Cover Page: Pre-Bid Minutes, Questions, Addenda

Subject: **Addendum No. 1** to Bid Documents
Poc903130C Nutrient Reduction Wetland Project – Bid No. 24-01
Greene County, Iowa

POCAHONTAS COUNTY WETLAND PROJECT
POC903130C - BID NO. 24-01
PREBID MEETING
March 19, 2024 - 10:00 AM
Manson Public Library
1312 10th Ave, Manson, IA
712-469-3986

Attachment No. 1 – Sign Installation Detail

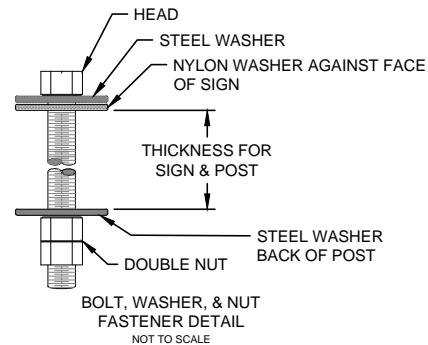
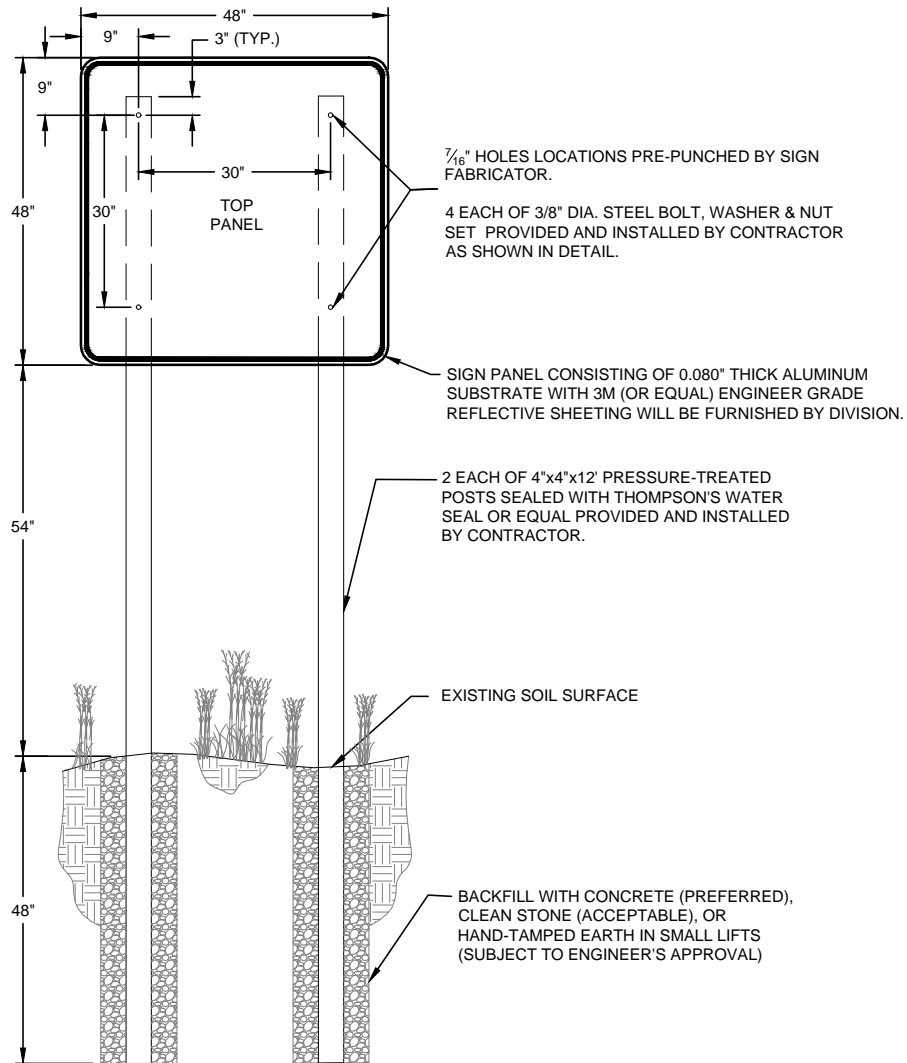
SPECIFICATION CS-008 4.B.3

Add the following paragraph:

3. **Subsidiary Item: Sign Installation**

This item shall include all labor, materials, equipment, and Iowa One Call notifications to install sign provided by Iowa Department of Agriculture and Land Stewardship, as shown on attachment.
